Mawna Fashions LTD. (EXTENSION)

18 December 2024

1. Building Information

Single Storied Shed

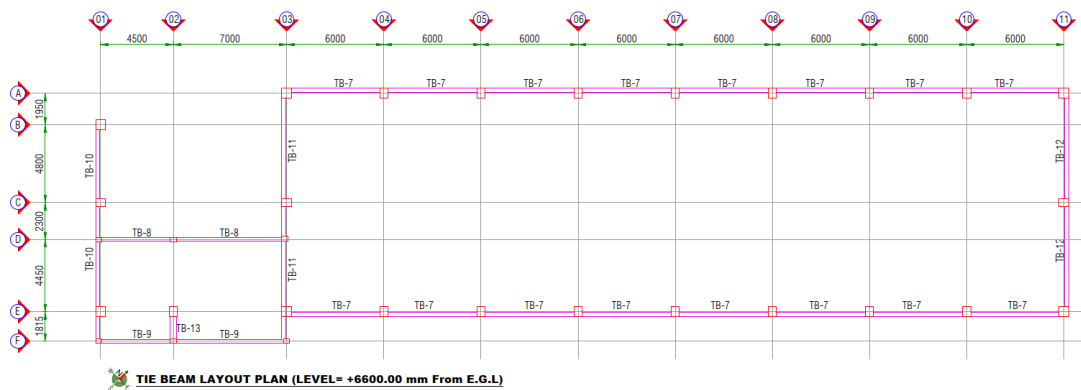
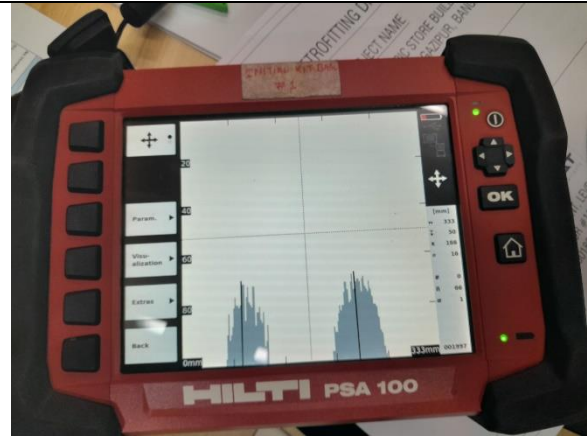
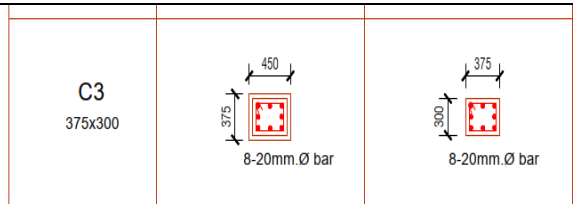
Description: The amount of rebar of the C3 column was found 6 instead of 8. Grid-wise sectional details missing in long-direction grids.

Building engineer is required to confirm all types of column rebar by ferro scanning or strip cutting update the drawing and prepare a detailed accurate structural drawing.
